PLAN AT EL. +24'-10 1/2"

JOB NO : 25743
11-05-2025 GELINAS COMMENTS

D. CRONIN'S WELDING SERVICE, INC. 70 STATE ST., LAWRENCE, MA 01843 TEL: 978-664-4488 FAX: 978-664-1958
PROJECT NAME:	38 OLD COLONY AVENUE
LOCATION:	QUINCY, MA
ARCHITECT:	DONAHUE ARCHITECTS, INC.
ENGINEER:	ROOME & GUARRACINO, LLC
CUSTOMER:	LEGACY ASSETS, LLC
DWG TITLE:	PLAT AT EL. 24'-10 1/2"

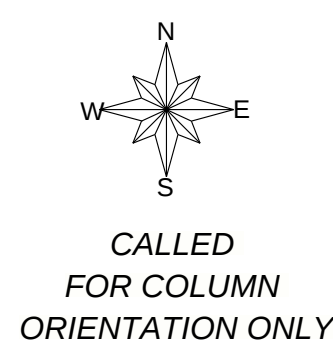
Change to bearing plates
3/8" with (2) 3/4" Studs
verify if is acceptable

Change to bearing plates
3/8" with (2) 3/4" Studs
verify if is acceptable

Change to bearing plates
3/8" with (2) 3/4" Studs
verify if is acceptable
